From: Pederson Ronda M (AREVA NP INC) [Ronda.Pederson@areva.com]
Sent: Monday, July 13, 2009 6:42 PM
To: Tesfaye, Getachew
Cc: BENNETT Kathy A (OFR) (AREVA NP INC); DELANO Karen V (AREVA NP INC); NOXON David B (AREVA NP INC)
Subject: Response to U.S. EPR Design Certification Application RAI No. 236, FSARCh. 19
Attachments: RAI 236 Response US EPR DC.pdf

Request for Additional Information No. 236

U. S. EPR Standard Design Certification

SRP Section: 19 - Probabilistic Risk Assessment and Severe Accident Evaluation

Figure 19-309-1—MAAP Plot of Containment Pressure for SLBI Sequence with Four SG Blowdown and Failed MFW Isolation (Extended to 24 hours)

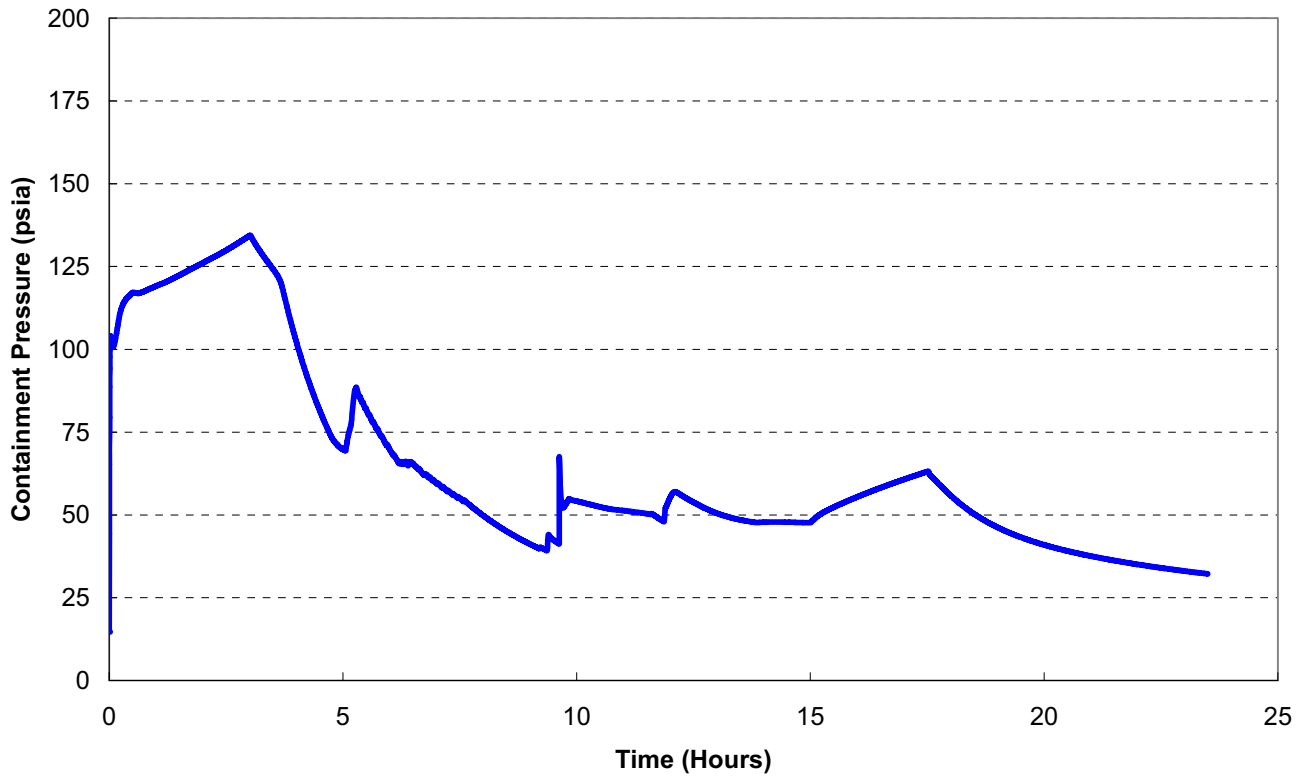
In response to RAI 19-160, the results of EPR-specific RELAP5 analyses are presented for a main steam line break inside containment for about 3 hours after accident initiation. These results show that after 2.8 hours, the containment pressure is within ~45 psi of the median failure pressure of the containment.

Please provide the results of the analyses that extend to 24 hours and supply all the “best estimate” reactivity coefficients used in these analyses (i.e., Boron, Scram, Doppler and Moderator as a function of the relevant independent variable).

The Response to RAI 19-160 (set 22, supplement 3) included a RELAP5 analysis. Because the RELAP5 analysis lacks a containment pressure response, a separate MAAP4 analysis was performed to determine the containment pressure response. This MAAP4 analysis has been extended to 24 hours and the containment pressure is shown in Figure 19-309-1.
